FIELD CHANGE ORDER

Reference No. : 00 135 012

OPTIMUS RAD 50

X-Star tube and Rotor Control replacement

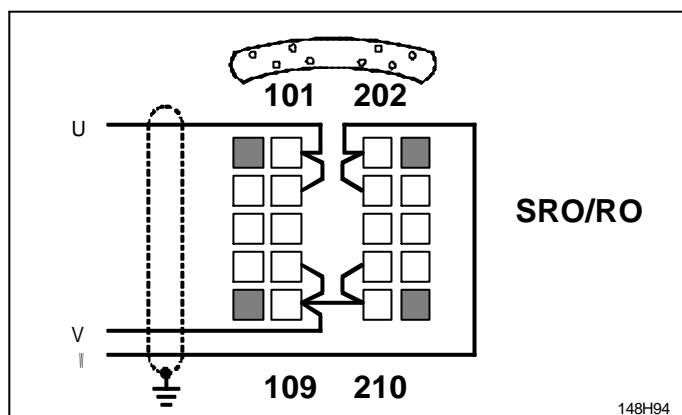
1. Replace the tube
 - Install the stator cable like an Stator connection

At the tube end:

- Place the jumpers across terminals 100 and 200 accordingly.
- Connect up stator cable.
 - Use wire 1 for phase U,
 - wire 2 for phase V,
 - wire 3 for phase W.
- Earth the screening of the stator cable at the tube housing with the metallic clamp.
